**SECTION 96(2) APPLICATION**  
**MODIFICATION OF CONSENT No.267-11-99**  
**ROBERTS ROAD**  
**MARROTA**

17 July, 2000

This report has been prepared in support of an application pursuant to Section 96 (2) of the Environmental Planning and Assessment Act, 1979 to amend the abovementioned consent.

**YEAR 8 PROGRESSIVE REHABILITATION PLAN & SECTION - STAGE 2 WORKS**

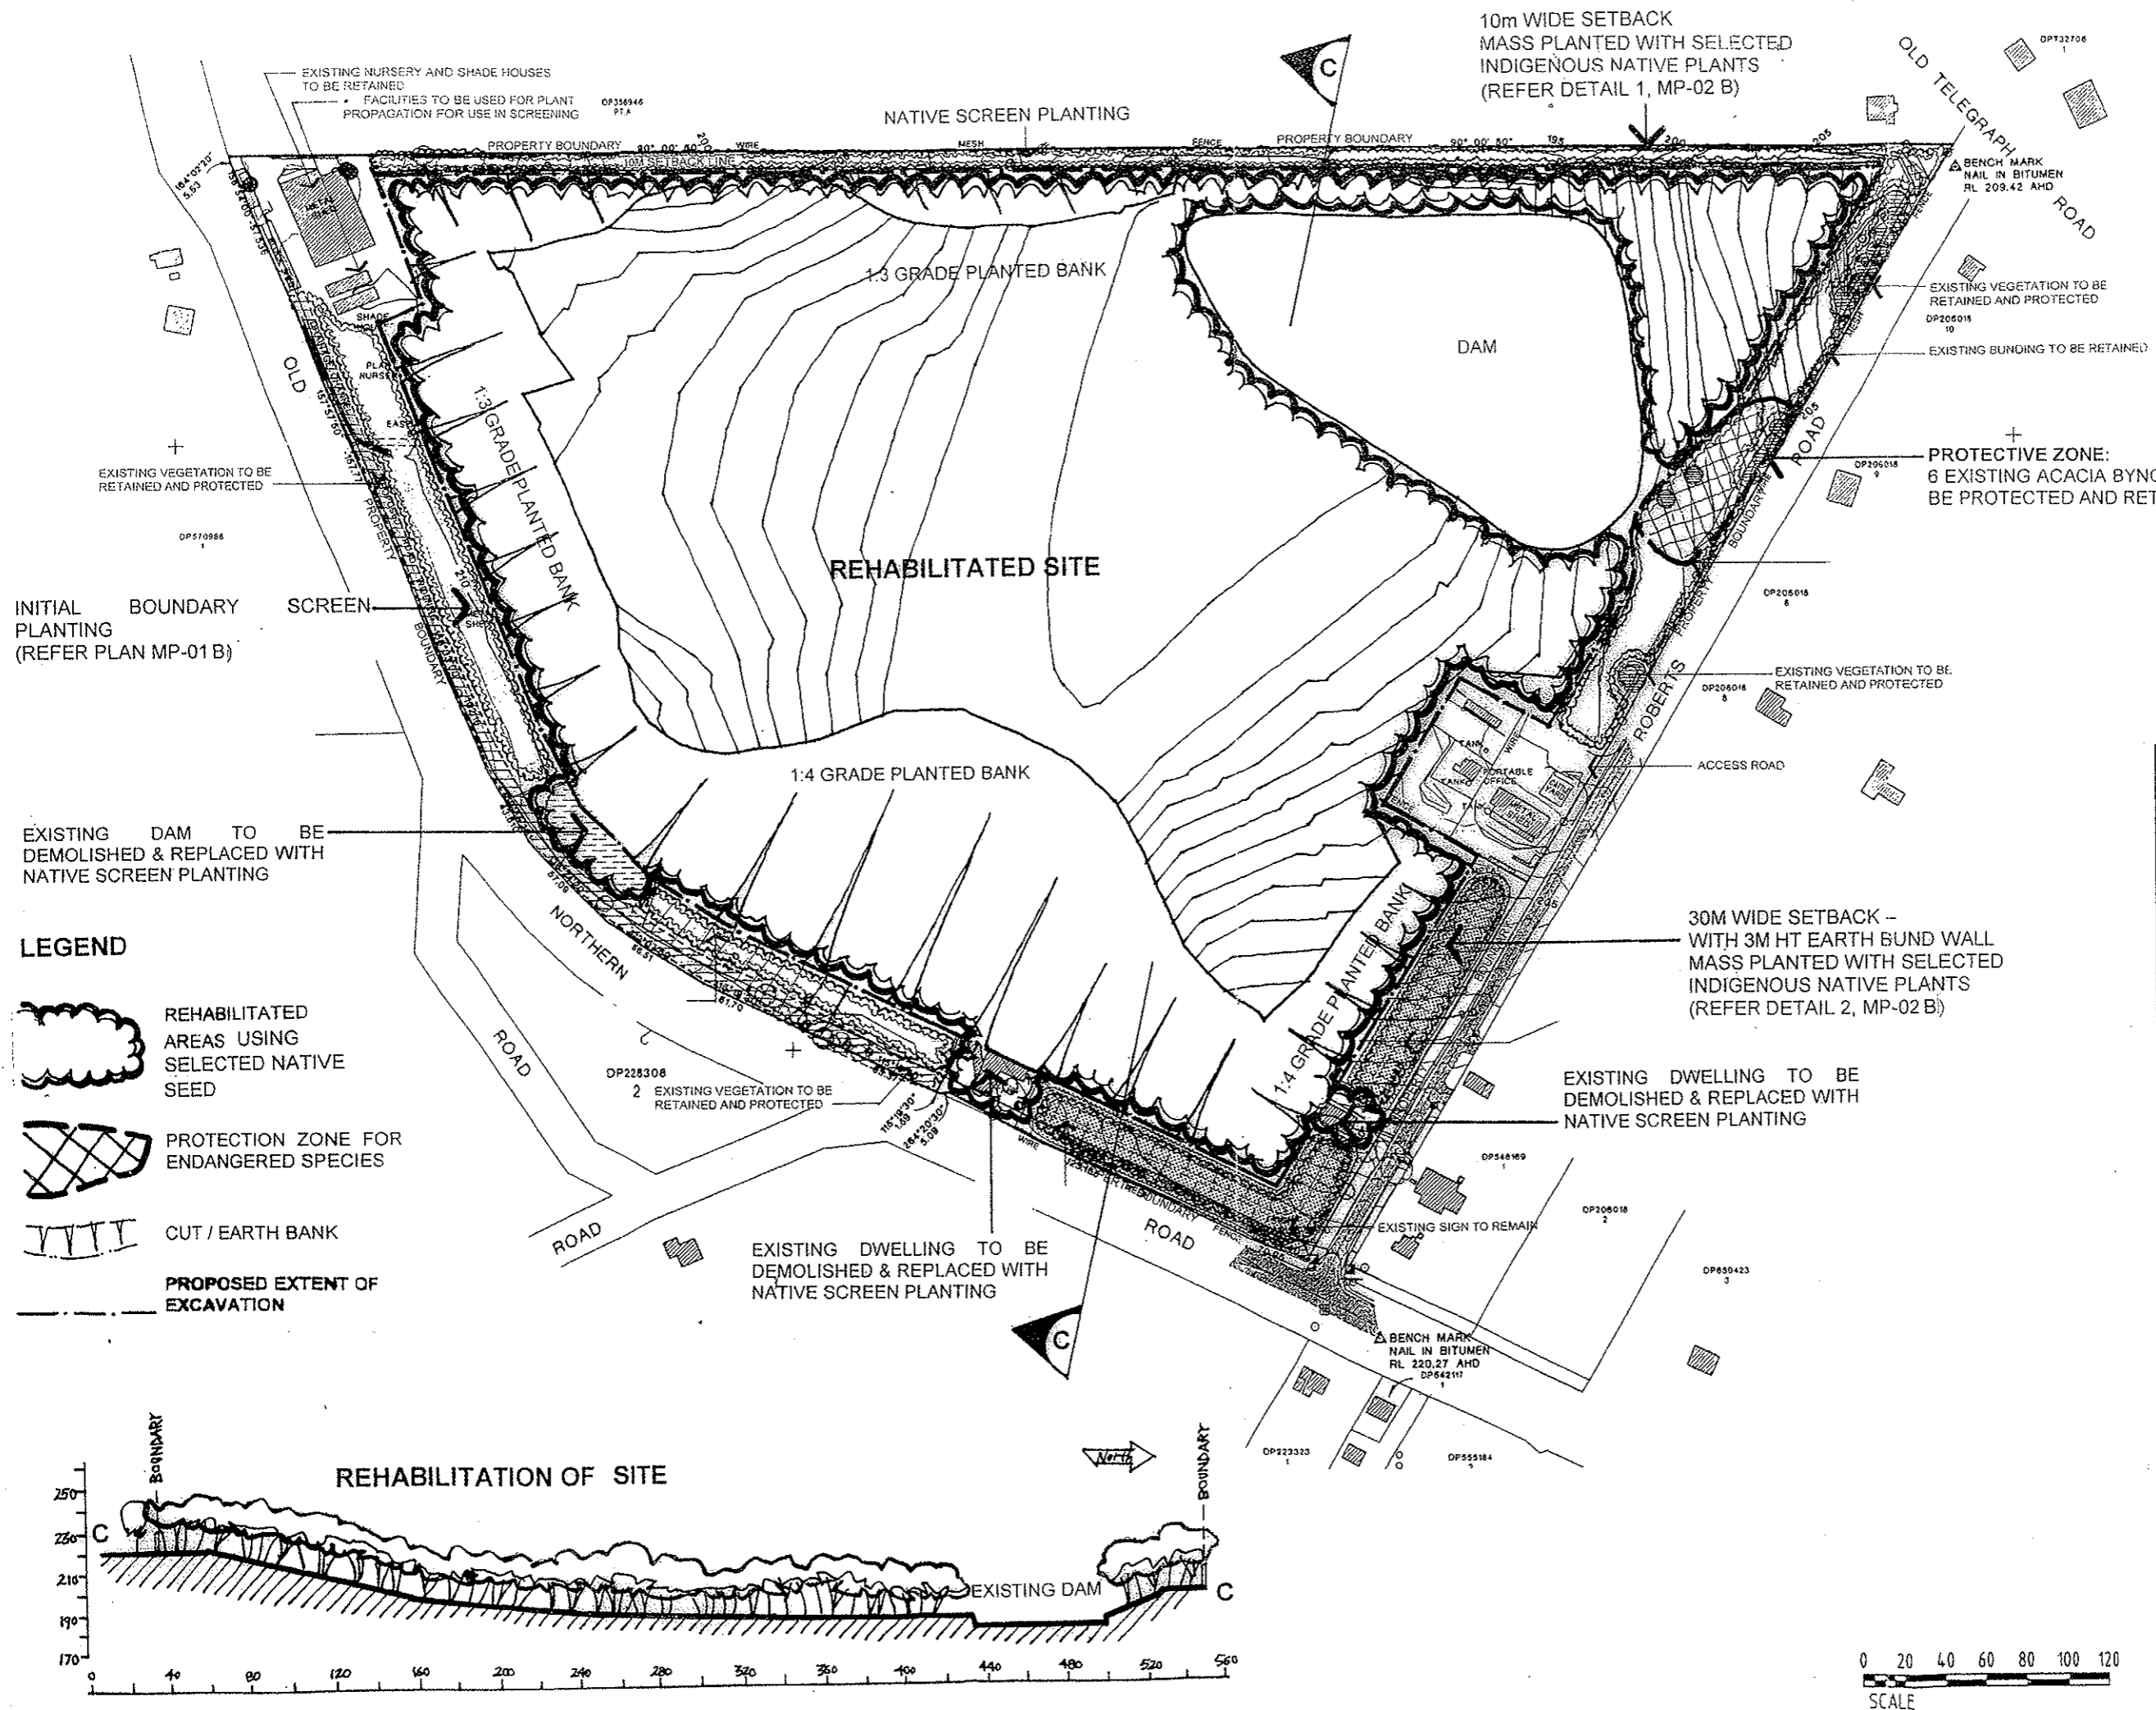
North point			
B	D.A. ISSUE - BUND REMOVED IN SELECTED AREAS	JULY 00	
A	D.A. ISSUE	OCT 99	
Issue	Rev.	Revision Description	Date
Landscape Architect			
<b>SCOTT MURRAY &amp; ASSOCIATES</b> Landscape Architecture Golf Course Architecture Environmental Planning Urban Design 79 Zig Zag Lane, Crooks Nest NSW 2065 Telephone 02 9438 9340 Facsimile 02 9439 9287 Email sma@tpg.com.au			
Prepared by			
<b>NEXUS ENVIRONMENTAL PLANNING PTY LTD</b>			
Project			
<b>LOT 1 + 2 DP 228308          LOT 2 DP 312327          MAROOTA</b>			
Title			
<b>FINAL LANDFORM / REHABILITATION PLAN</b>			
Scale:	SMA Proj. No.		
Drawn	Checked	Coordinated	PIA Approval
Date			Director Verification
Job Number - Drawing Number			Issue
MP-05			B
